This document responds to the Corps of Engineers letter dated September 2, 2020, and clarification provided by Jacalen Printz by email on September 4, 2020. The components of this response include:

A. Proposed Approach to Stabilizing the Work Site and Minimizing Impacts Until Next Work Window

PHASE 1 CONSTRUCTION SEQUENCING SITE PLAN

DIVERSION REPAIR, SPILLWAY REPLACEMENT AND BANK PROTECTION

Figure 1

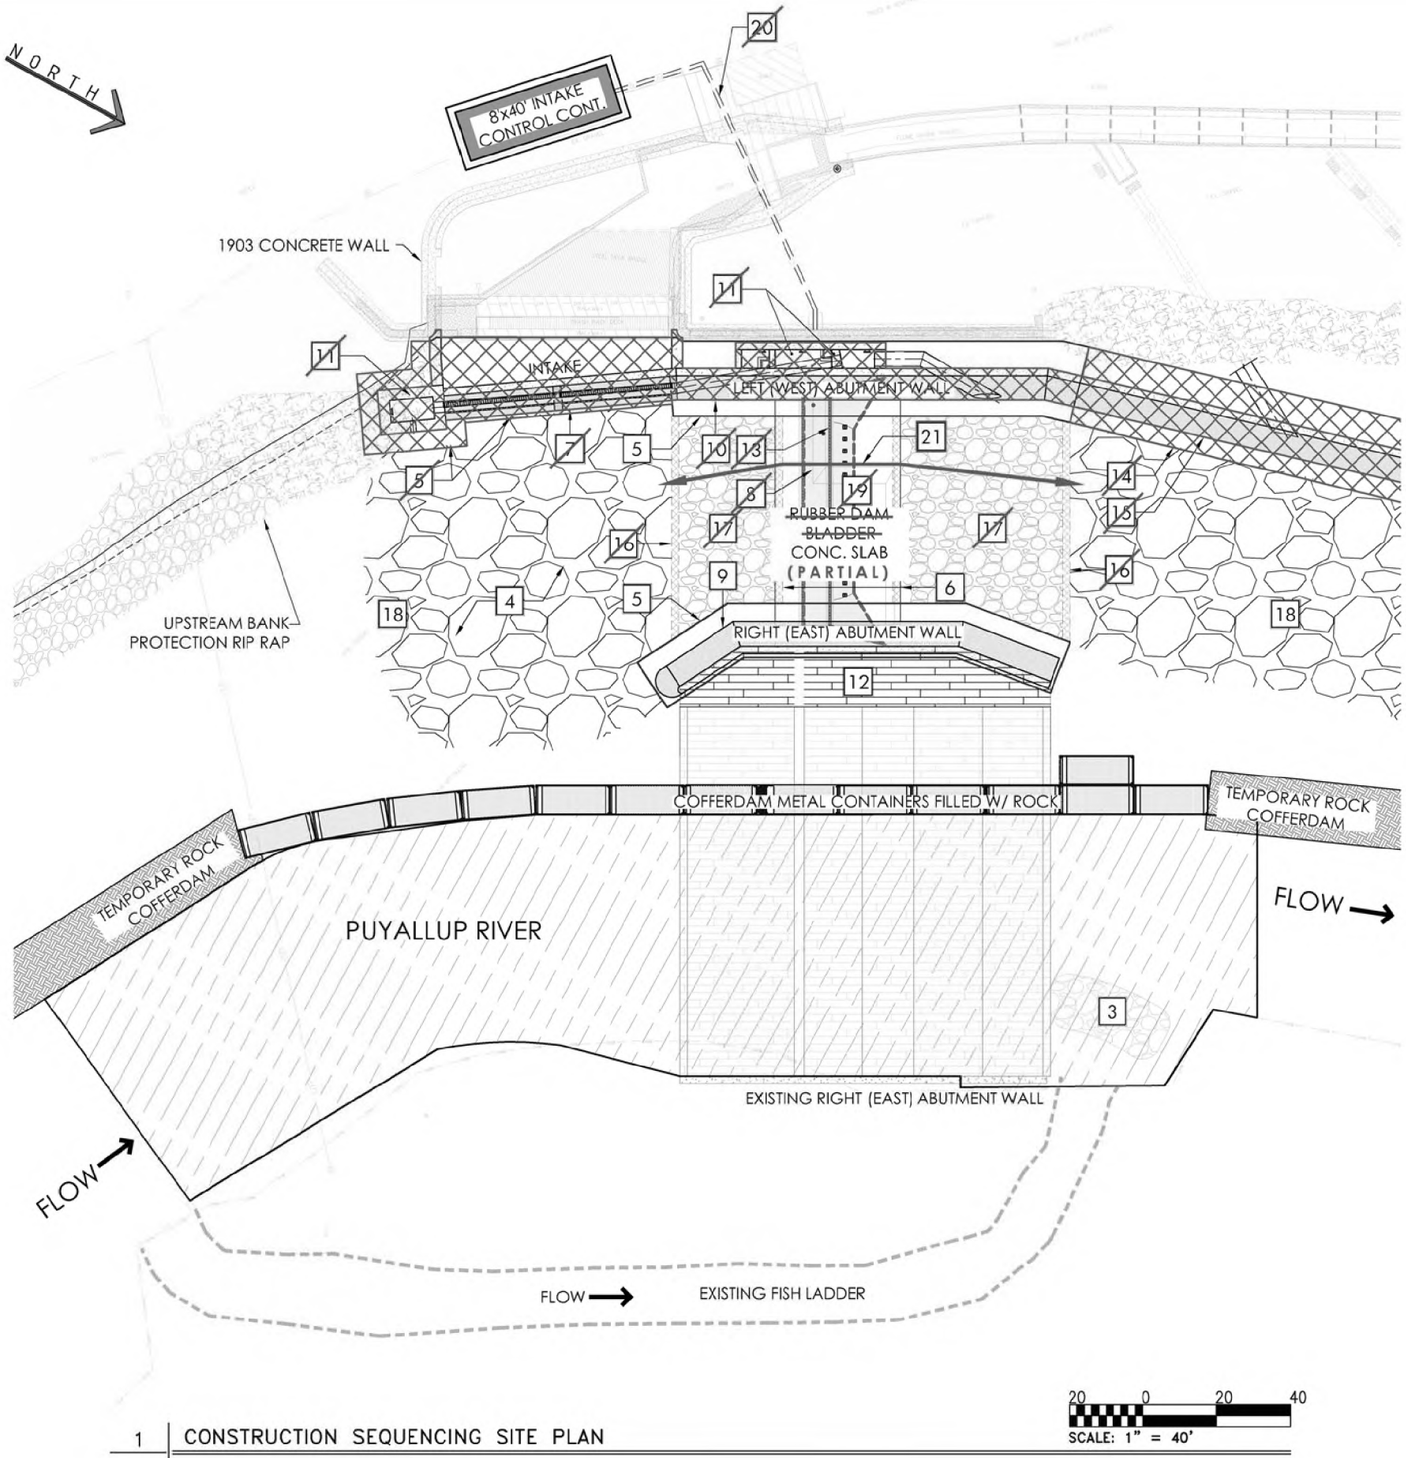
Attached is a modified Electron Intake Construction Sequencing Plan (**Figure 1**) that itemizes the sequence of the completion of Phase 1. This is to construct only the minimum work required to stabilize the work site. From the plan on **Figure 1**, only items 3, 4, 5 as modified, 9, 12, 13 as modified, 18, and 21 would be constructed.

I have not included items 16 and 17 due to the requirement of "minimum work required" to stabilize the work site. However, this would add sliding resistance, and stability to the center wall and rock diversion foundation, which I recommend.

Items 18 and 21 include placement of large rock in the areas indicated on **Figure 1**. Typical rock material will be large boulders (e.g. 6-man rock and larger) overlying smaller rock, placed by excavator. The approximate total area for rock placement will be 3,200 sq. yd. and the approximately total volume of rock will be 8,500 CY. This rock placement will be temporary to stabilize the work site from October 2020 to July 2021.

5 FORM AND POUR FOUNDATIONS FOR THE EAST ABUTMENT WALL THEN ~~INTAKE AND~~ WEST ABUTMENT WALL

13 CONCURRENT TO THIS, FORM, ~~PLACE EMBEDS,~~ AND **POUR PARTIAL REINFORCED SLAB** ~~POUR SLAB BETWEEN THE TWO ABUTMENT WALLS~~

18 PLACE LARGE RIP RAP DOWNSTREAM OF THE DOWNSTREAM OF THE LOWER CUTOFF WALL, AND UPSTREAM OF THE UPSTREAM CUTOFF WALL

21 PLACE LARGE ROCK IN LOCATION OF REMOVED WOOD DIVERSION TO ELEVATION 1620'

COFFERDAM SITE PLAN AND PROFILE

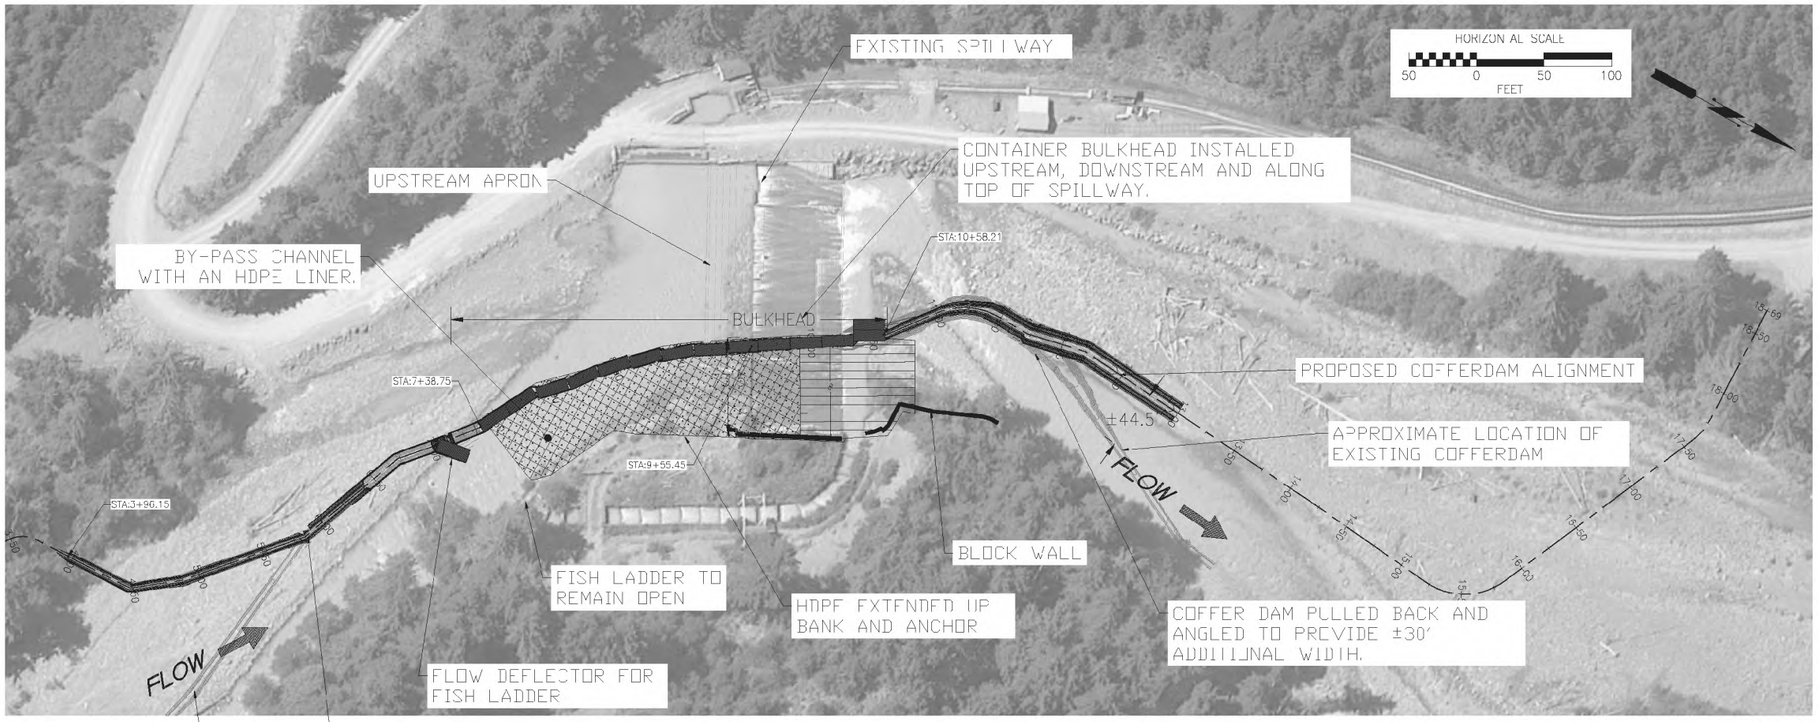
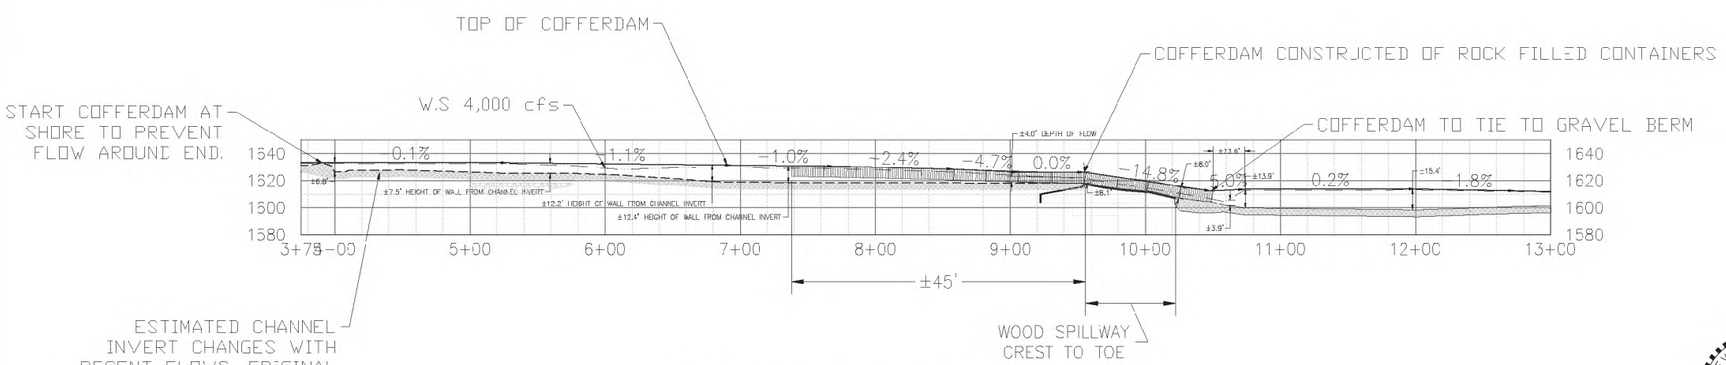
The existing cofferdam can be modified to prevent flows up to 4,000cfs from entering the construction work area. Modifying the current cofferdam profile and alignment at the upstream end and downstream end can provide this protection.

The upstream alignment starts a deflection toward the left bank shore about 600' from the start of the current cofferdam alignment. This provides more flow area reducing the velocity and ties into the left bank shore at higher elevation that will prevent flow passing behind the cofferdam.

Downstream, the cofferdam alignment was again deflected toward the left bank to provide more flow area to reduce water flow velocity.

There are draw-downs and hydraulic jumps that occur upstream and downstream from the bypass spillway. The largest jump occurs where the flow depth goes from about 4' to around 14' before leveling out. Upstream, the jump is less dramatic and occurs where a deflector has been placed opposite from the fish ladder to ensure adequate flow.

Velocities along the cofferdam range from 10-20 fps and 2-3 man rock should be placed at the toe of the cofferdam for one hundred feet downstream of the spillway and in the vicinity of the fish ladder flow deflector. Provided by: Steven P. Goodrich, P.E. WA PE-27025
